Product Change Notice

The JENSEN® VX7020A will be discontinued and will be replaced by the JRV9000 Touchscreen, Navigation, Multimedia System. This change will be effective approximately April 2017.

Notification Date: 1/3/2017

Comparison Drawing of the JRV9000 and the VX7020A:

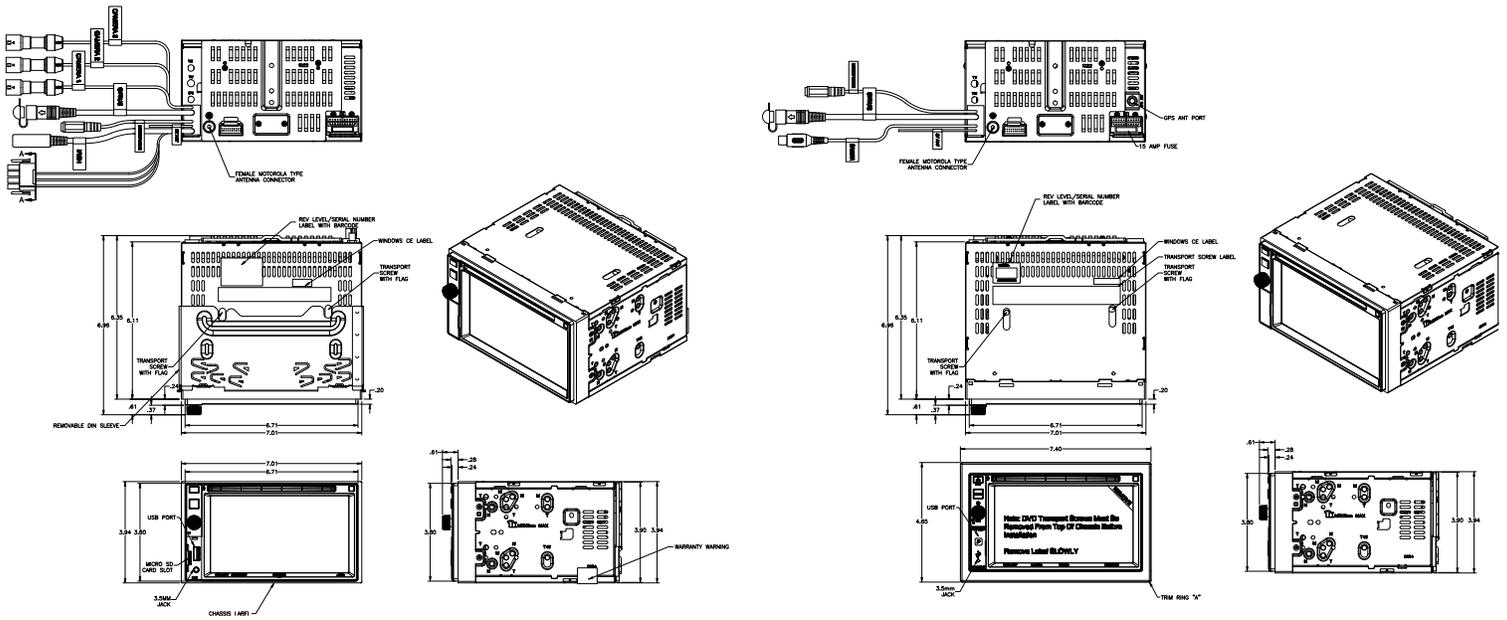
ALL CRITICAL DIMENSIONS ARE THE SAME
ONLY IOs HAVE CHANGED

JRV9000:

- 3 Camera inputs (CEC) with auto-trigger (CAM1 w/ audio)
- Adjustable display settings for camera modes (brightness, contrast, saturation, hue)
- MHL/HDMI smart phone connectivity
- 4x50W audio output power

VX7020A:

- Single RCA camera input (switcher box needed to add side cameras)
- Adjustable display settings for camera modes (brightness, contrast)
- Pandora Link Compatible
- 4x40W Audio Output Power
